# Access Compliance Report

## Public Rights-of-Way

### (Curb Ramps)

Intersection ID: 3642	Main Street: PERIMETER_WOODS_DR	Cross Street: PERIMETER_PY	Location: SW
ADA ID: B63AB0A2AA76	Ramp Type: Perp	Initial Pass/Fail: Fail	Overall Compliance: No
Severity Score: 21.25			
Codes/Mitigation Info/Possible Solution		Field Measurements/Component Compliance

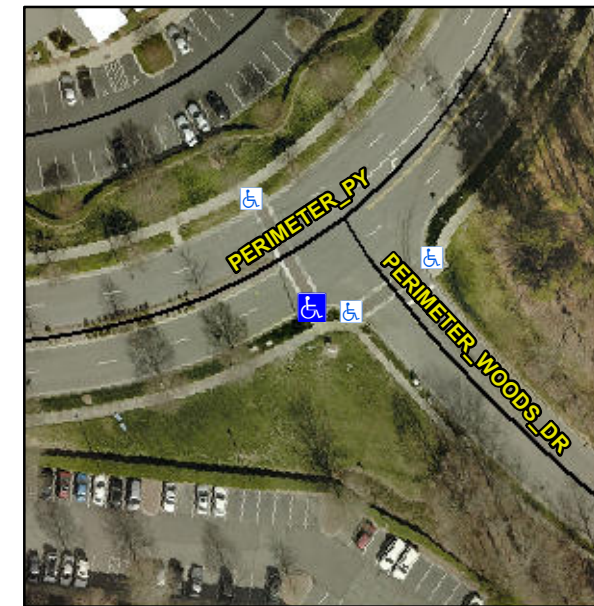
**Not Found, R304.5.1, R304.5.3**

Compliance	Description	Data	Compliance	Description	Data
N/A	Ramp Length (in)	88.0	Yes	Ramp Slope (%)	5.8
No	Ramp Width (in)	47.5	No	Ramp XSlope (%)	5.1
N/A	Flare Type LT	N/A	N/A	Flare Type RT	N/A
N/A	Flare Slope LT (%)	N/A	N/A	Flare Slope RT (%)	N/A
N/A	Flare Traversable LT?	N/A	N/A	Flare Traversable RT?	N/A
N/A	Landing Length (in)	N/A	N/A	DWS Provided?	N/A
N/A	Landing Width (in)	N/A	N/A	DWS Contrast?	N/A
N/A	Landing Slope (%)	N/A	N/A	DWS Length (in)	N/A
N/A	Landing X Slope (%)	N/A	N/A	DWS Full Width?	N/A
N/A	Landing Curb? (Y/N)	N/A	N/A	DWS Offset (in)	N/A
N/A	Shared Landing?	N/A			
N/A	Gutter Ponding?	N/A	N/A	Gutter Slope (%)	N/A
N/A	Gutter Lip Ht (in)	N/A	N/A	Gutter X Slope (%)	N/A
N/A	Painted X Walk1?	Yes	N/A	Painted X Walk2?	N/A
	X Walk 1 Direction	To NW		X Walk 2 Direction	N/A
N/A	X Walk 1 Width (in)	71.0	N/A	X Walk 2 Width (in)	N/A
	X Walk 1 Slope (%)	0.4		X Walk 2 Slope (%)	N/A
	X Walk 1 X Slope (%)	1.9		X Walk 2 X Slope (%)	N/A

**Remove & Replace Entire Ramp.**
